**PLANNING UNIT REPORT
DEPARTMENT OF PLANNING AND DEVELOPMENT
November 21, 2005**

RE: L.D. # 02144: Zoning Map Amendment L.D. 3145 to Rezone 702 N Midvale Blvd. from PUD- SIP to Amended PUD-SIP

SUBJECT: 702 North Midvale Boulevard Planned Unit Development (SIP) and Demolition

SUBJECT: **702 North Midvale Boulevard – SIP Amendment #1 – Hilldale Restaurant**

Site Layout Plan
 Hilldale PUD-GDP-SIP Amendment #1
 Restaurant / Water Feature

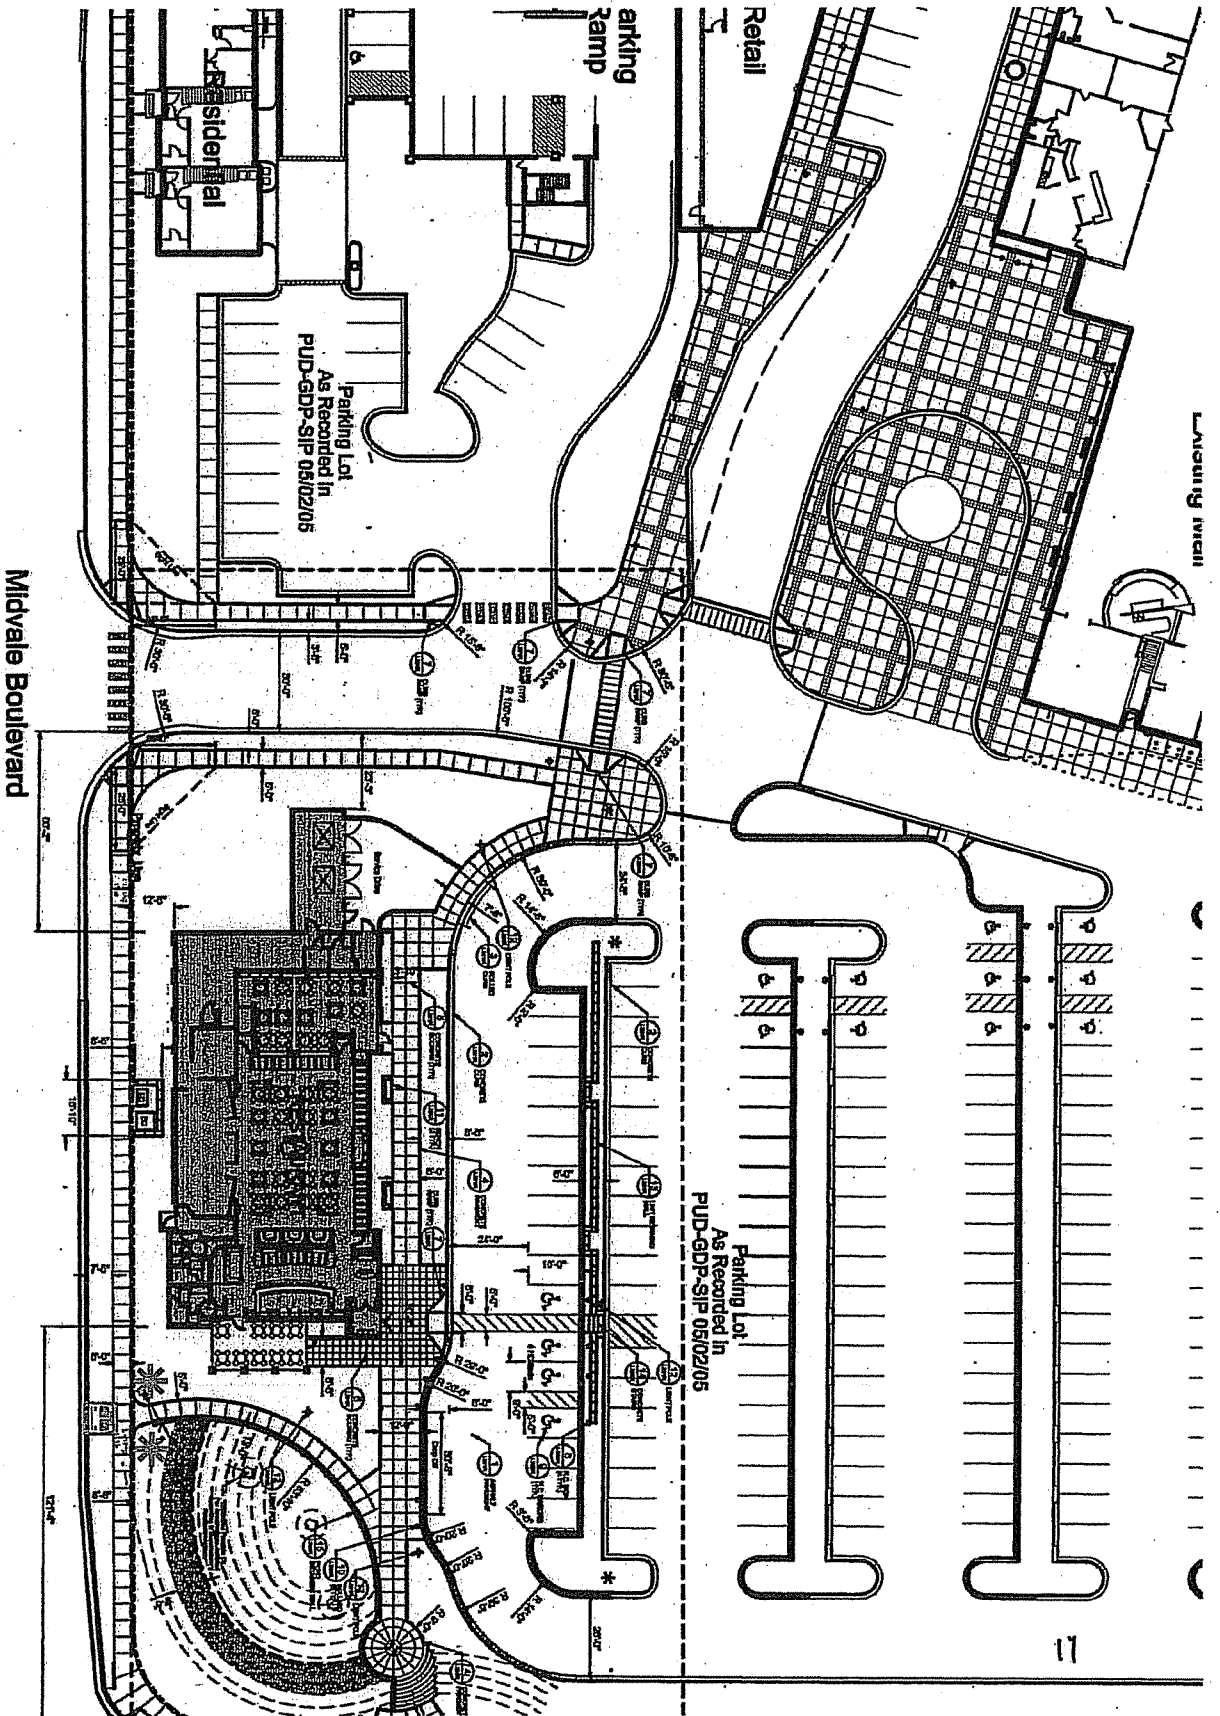
1. The applicant shall install a concrete passenger boarding pad on the west side of Midvale Boulevard, approximately 100 feet south of University Avenue, generally opposite the accessible pedestrian walkway. The concrete pad shall occupy the full distance of the terrace, measure 6 feet in width parallel to the street, and lie flush between the sidewalk and the top of curb.
2. The developer shall install and maintain a bench or other seating amenity and a trash receptacle on the property side of the sidewalk, to either side of the accessible pedestrian walkway apron.
3. The developer shall include the location of this concrete passenger boarding pad and the passenger amenities on the final documents filed with their permit application so that Metro Transit may review and approve the design.

Seating and trash
 site options

Concrete passenger
 boarding pad si
